PIC18F87K90 Family Silicon Errata and Data Sheet Clarification

The PIC18F87K90 Family devices that you have received conform functionally to the current Device Data Sheet (DS39957B), except for the anomalies described in this document.

The following typographic corrections and clarifications are to be noted for the latest version of the device data sheet (DS39957B):

FIGURE 2-3 FREQUENCY vs. ESR PERFORMANCE FOR SUGGESTED VCAP

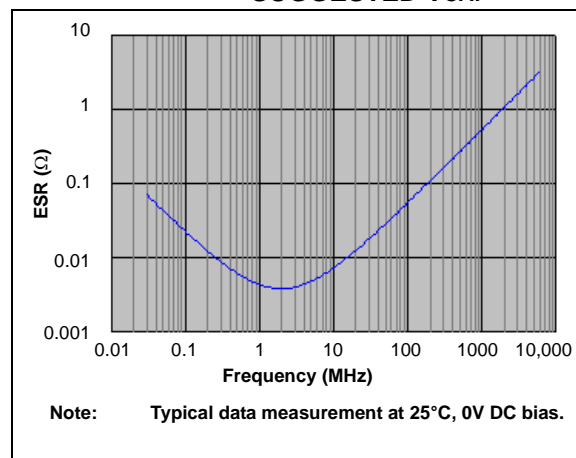
2. Module: Voltage Regulator Pins (ENVREG and VCAP/VDDCORE)

The note in [Figure 2-3](#) contains specific information for the Murata capacitor. [Figure 2-3](#) now shows a typical frequency vs. ESR performance for all recommended capacitors with a note that applies to all suitable capacitors.

FIGURE 2-4 DC BIAS VOLTAGE vs. CAPACITANCE CHANGE CHARACTERISTICS

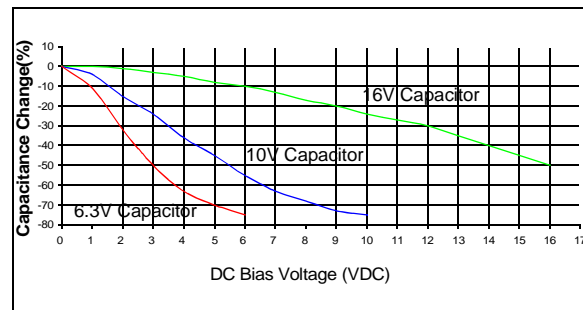
Section 2.4.1 is added to **Section 2.4 Voltage Regulator Pins (ENVREG and VCAP/VDDCORE)** as shown below:

In addition to temperature tolerance, the effective capacitance of large value ceramic capacitors can vary substantially, based on the amount of DC voltage applied to the capacitor. This effect can be very significant, but is often overlooked or is not always documented.

Typical DC bias voltage vs. capacitance change graph for 16V, 10V and 6.3V rated capacitors is shown in [Figure 2-4](#).

When selecting a ceramic capacitor to be used with the VDDCORE voltage regulator, it is suggested to select a high-voltage rating, so that the operating voltage is a small percentage of the maximum rated capacitor voltage. For example, choose a ceramic capacitor rated at 16V for the 2.5V VDDCORE voltage. Suggested capacitors are shown in [Table 2-1](#).
